Project: San Angelo ISD Paging Upgrade (RFP #26-008)

Subject: Addendum 01

TECHNOLOGY ITEMS FOR ADDENDUM 01

FLOOR PLAN - CENTRAL
HS - BUILDING H - TENNIS

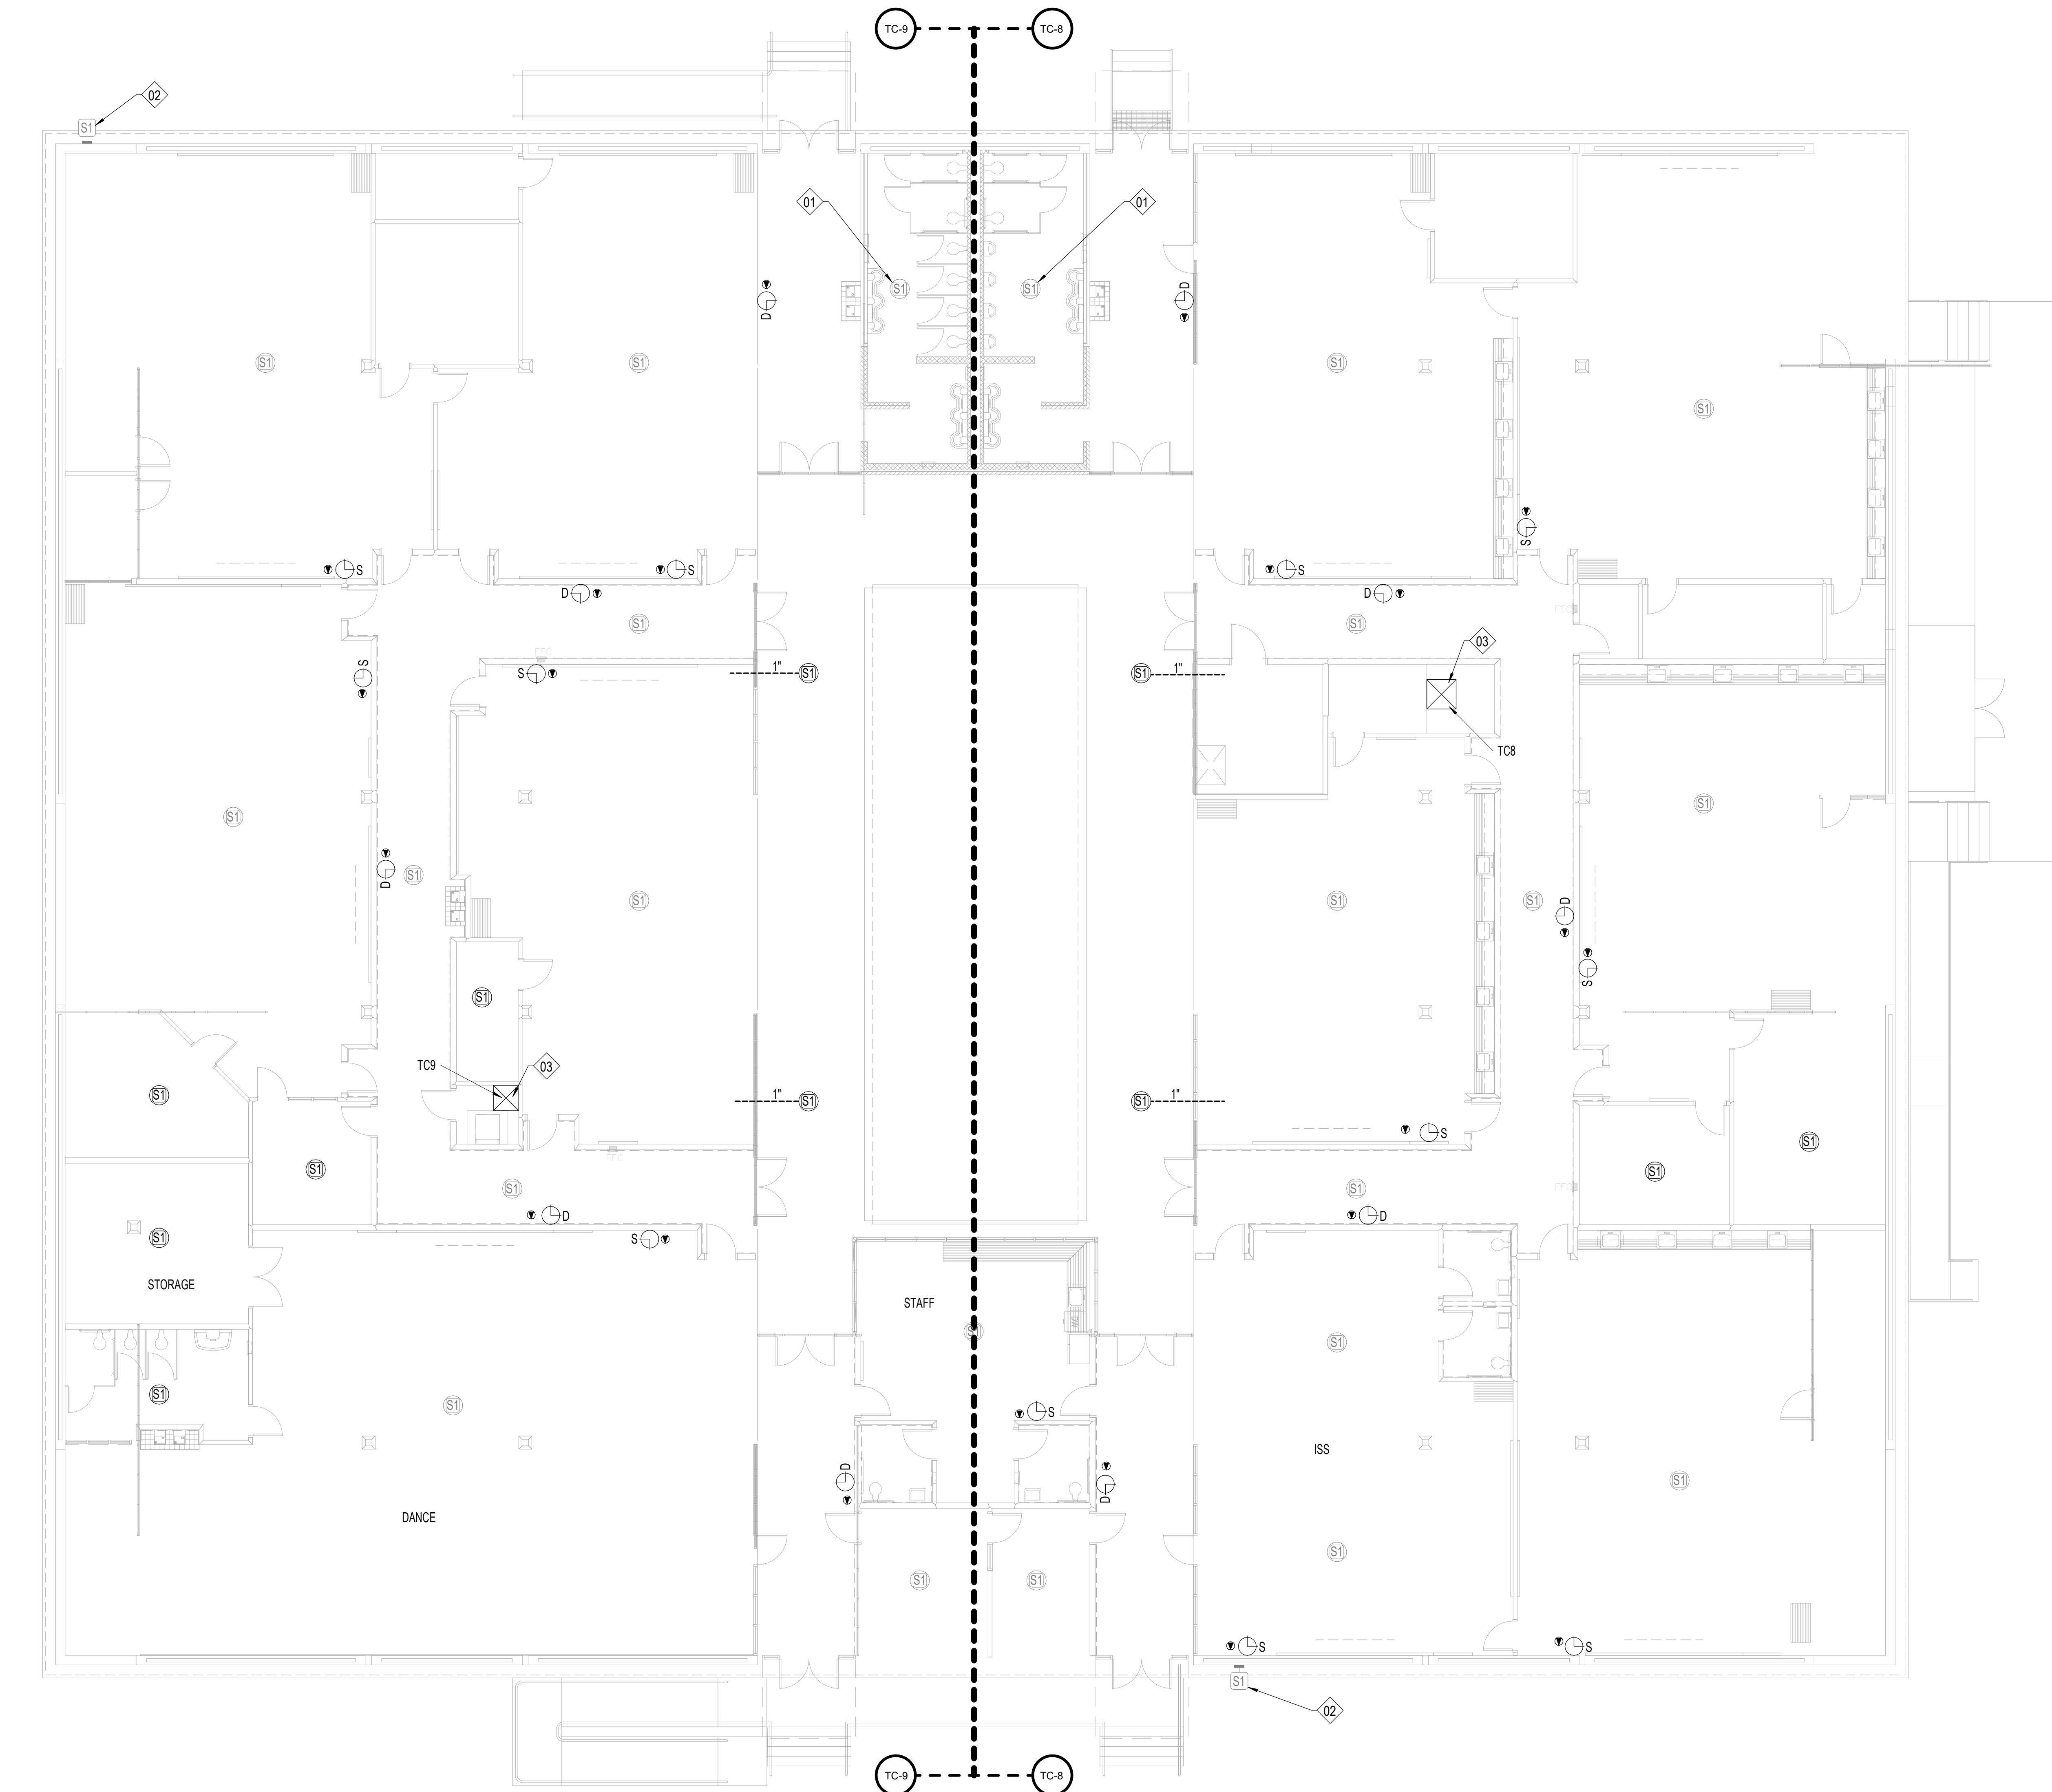
ADD No 1, Tech. Item 11: To the Drawings, Sheet T109, “FLOOR PLAN - CENTRAL HS - BUILDING H - TENNIS,”

- 1) Added halftone speaker clarification to Sheet Notes.
- 2) Added paint/finish clarification to Sheet Notes.
- 3) Clarified high-ceiling lift requirement item in Sheet Notes.
- 4) Modified/consolidated Keynote 16/17.

FLOOR PLAN - CENTRAL
HS - BUILDING K - BACON

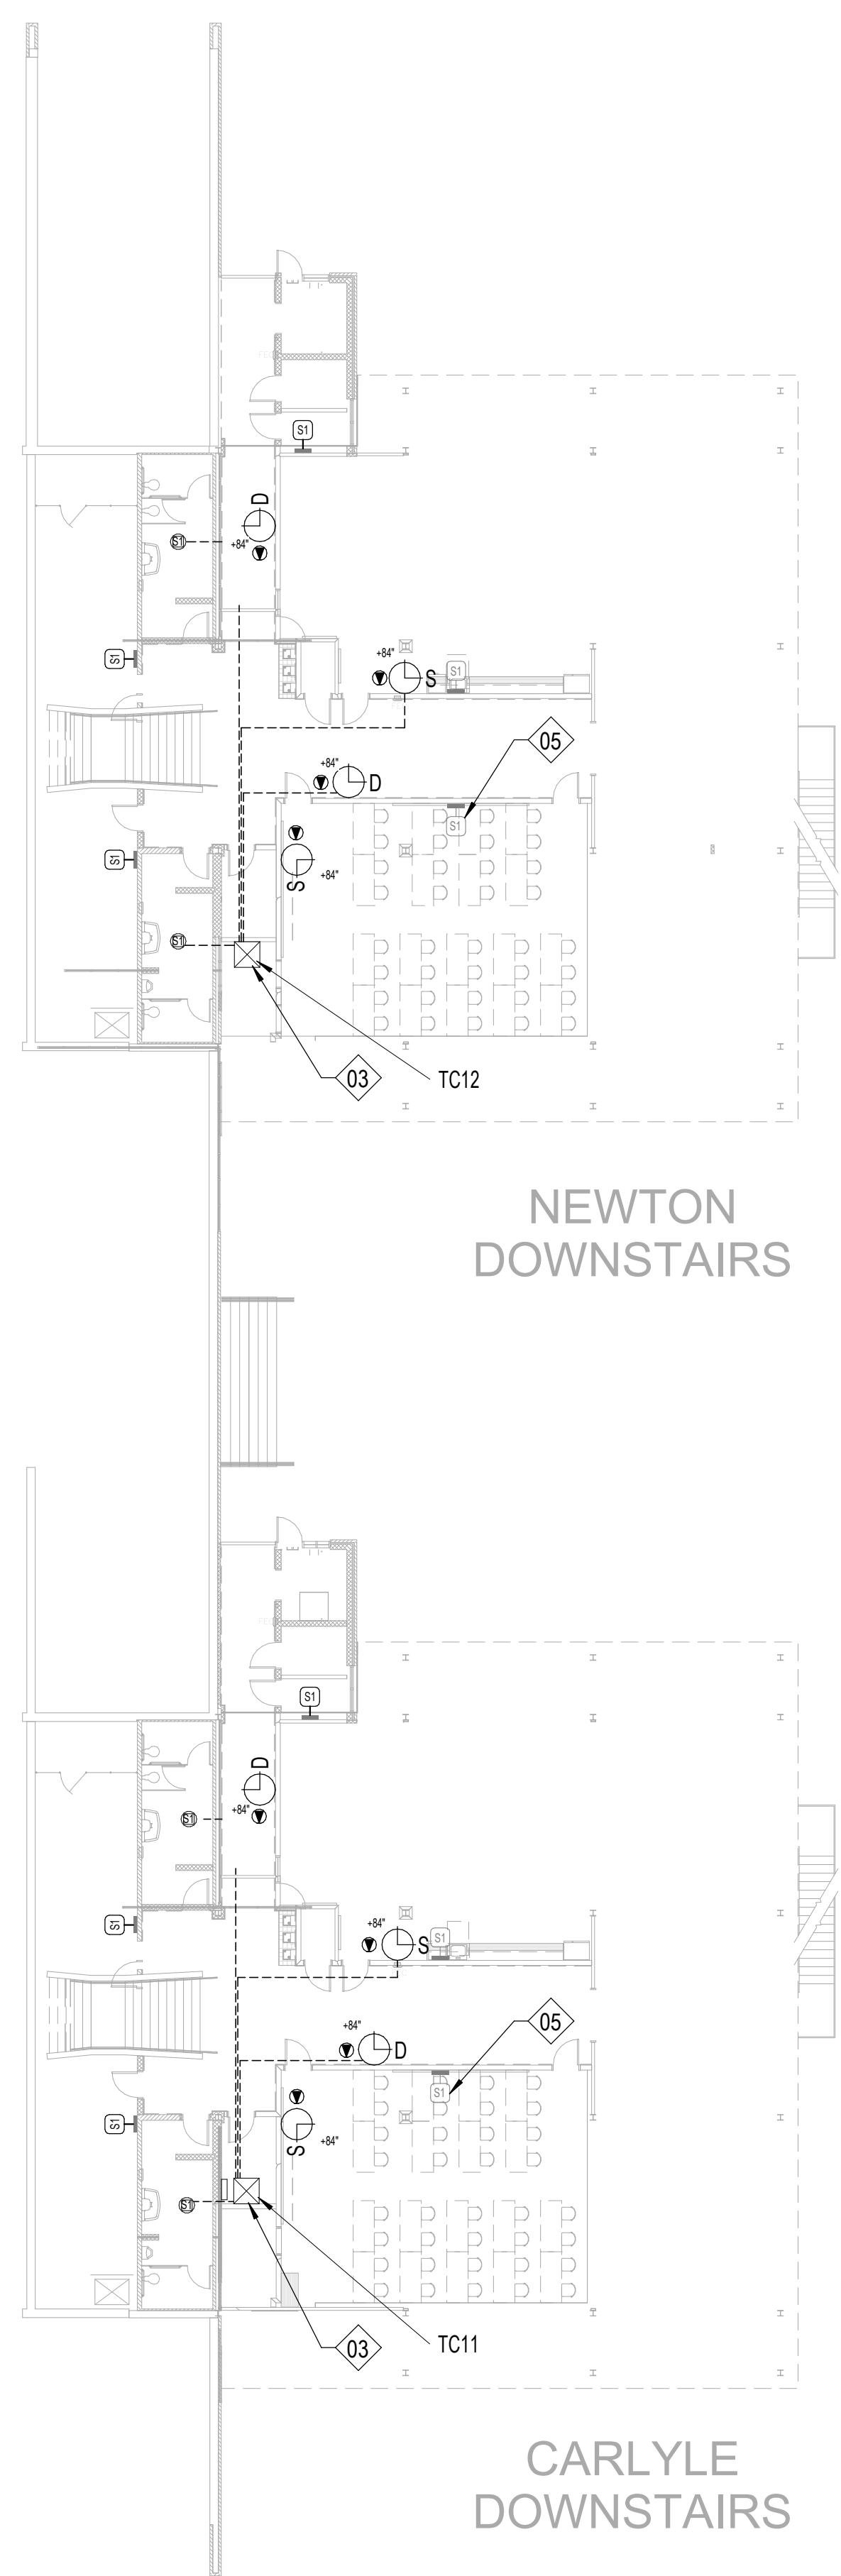
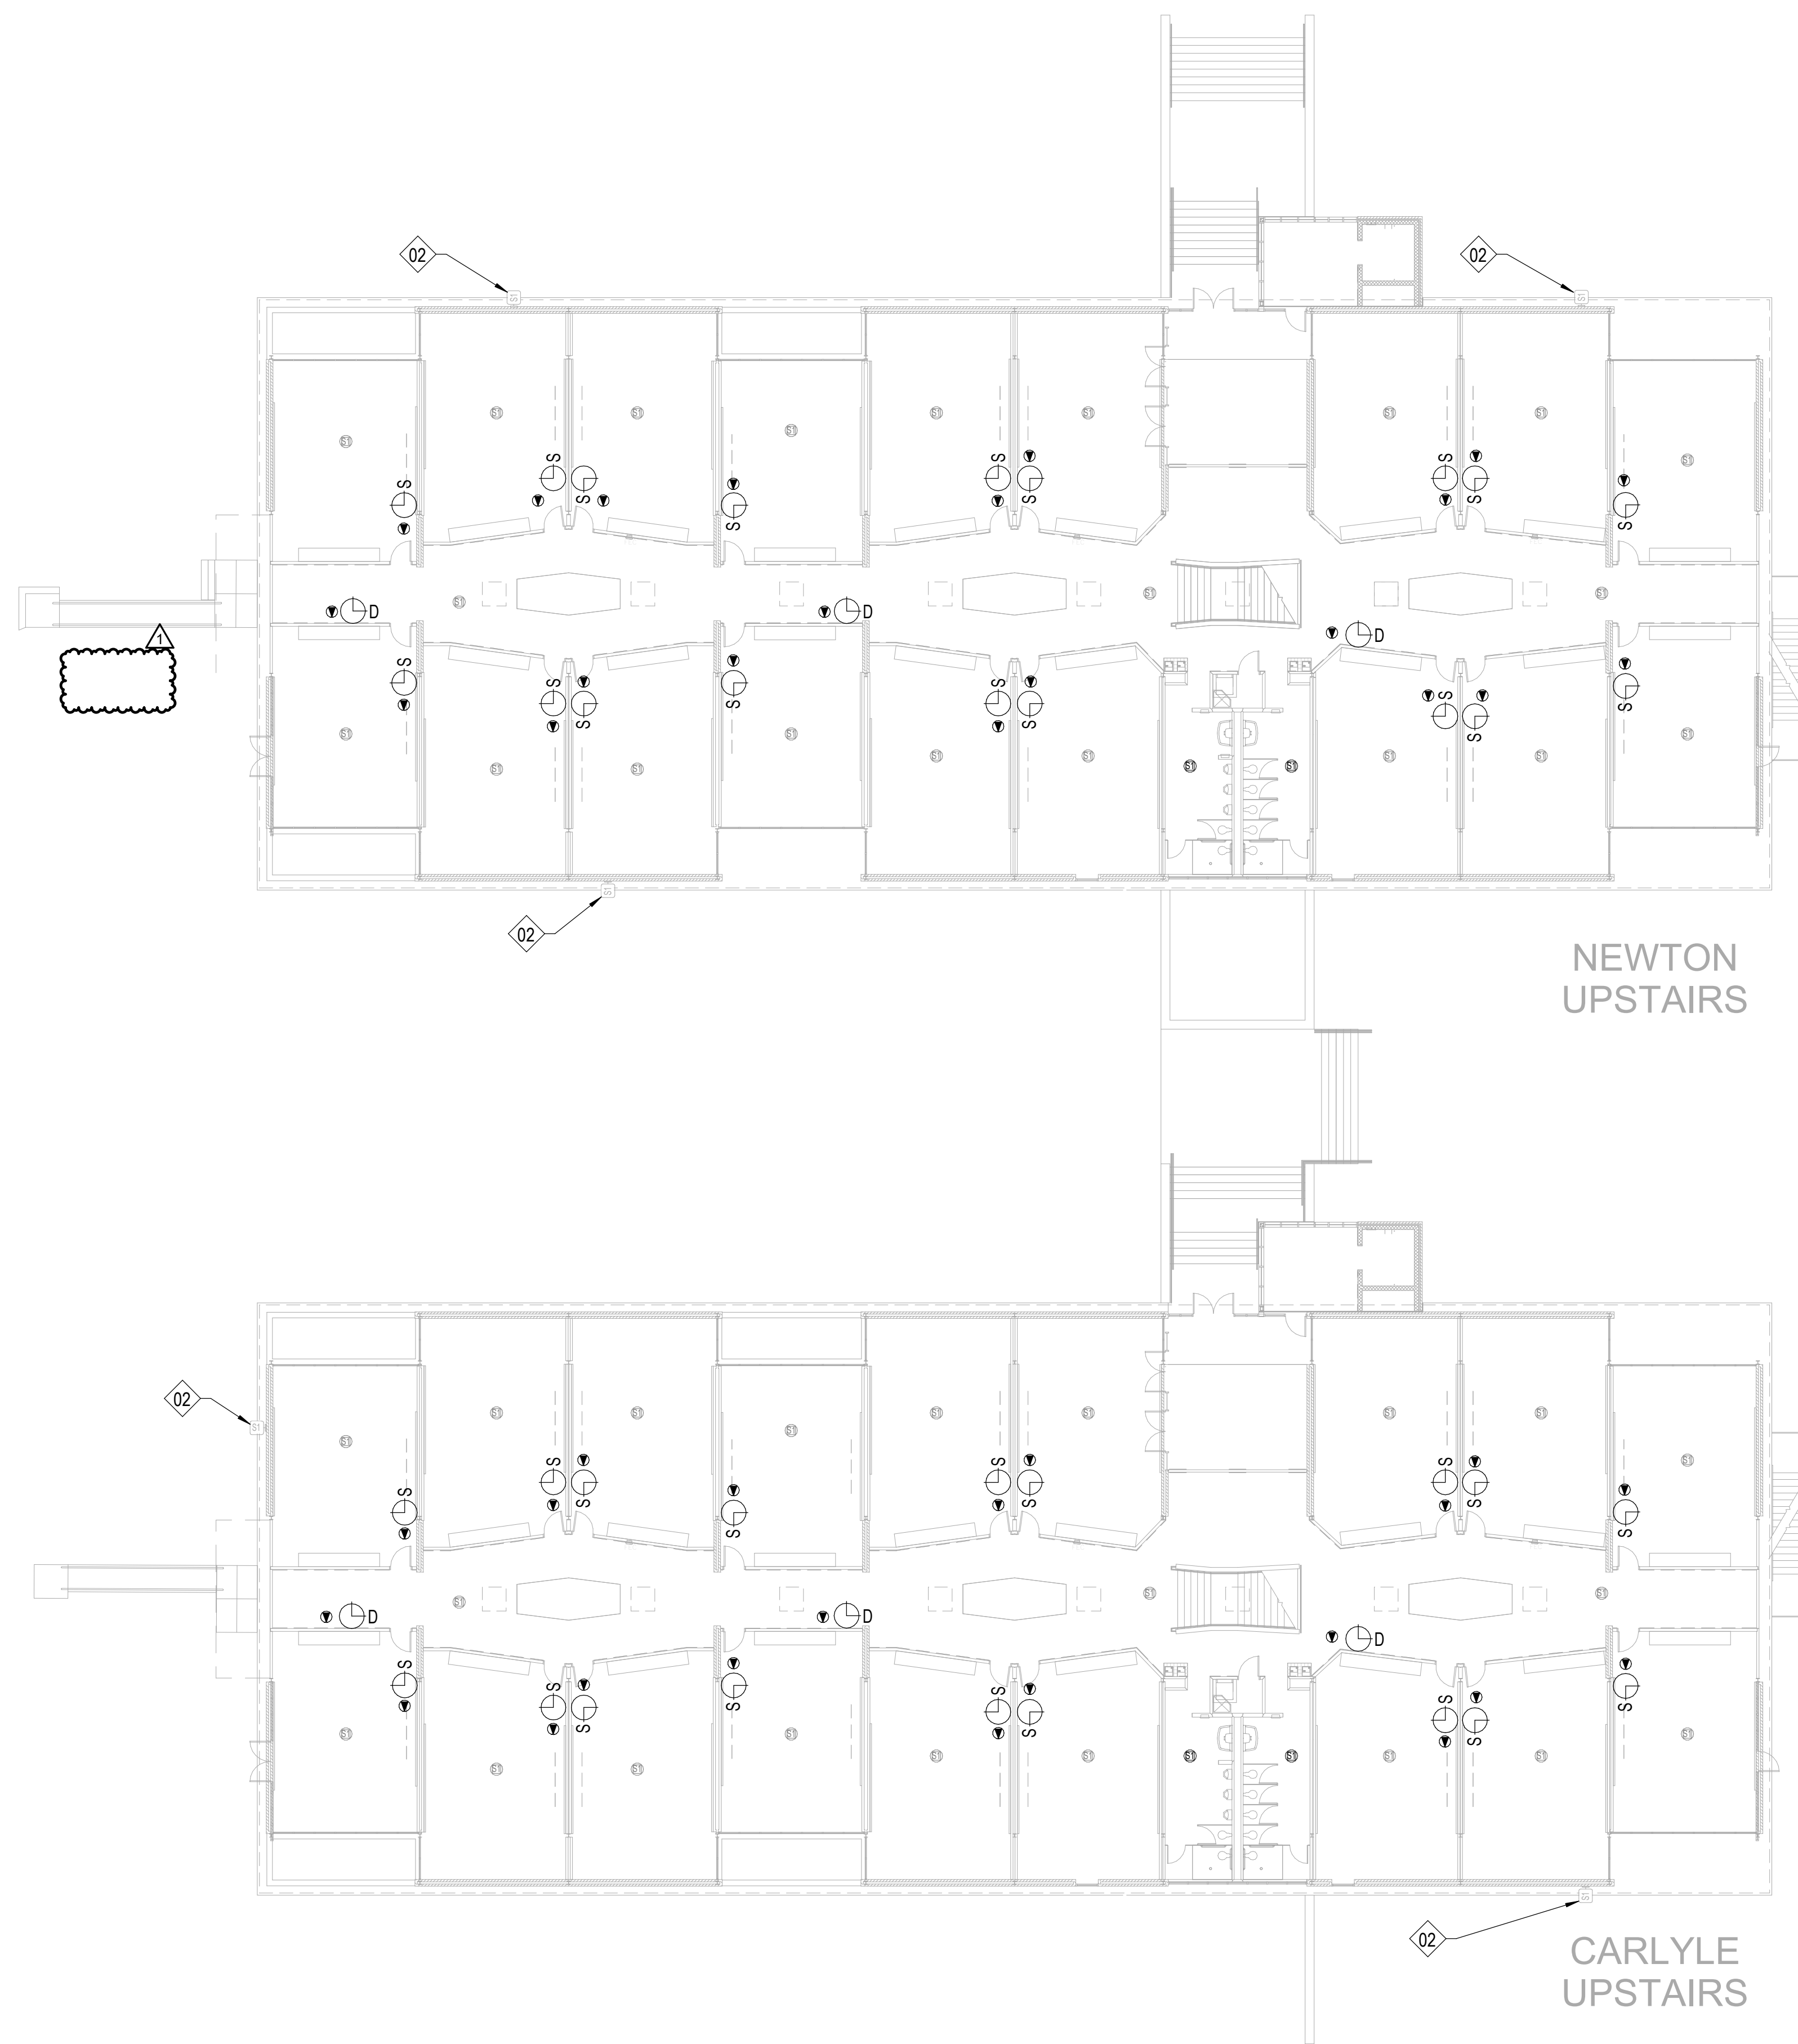
ADD No 1, Tech. Item 14: To the Drawings, Sheet T112, “FLOOR PLAN - CENTRAL HS - BUILDING K - BACON,”

- 1) Added halftone speaker clarification to Sheet Notes.
- 2) Added paint/finish clarification to Sheet Notes.
- 3) Clarified high-ceiling lift requirement item in Sheet Notes.
- 4) Modified/consolidated Keynote 16/17.
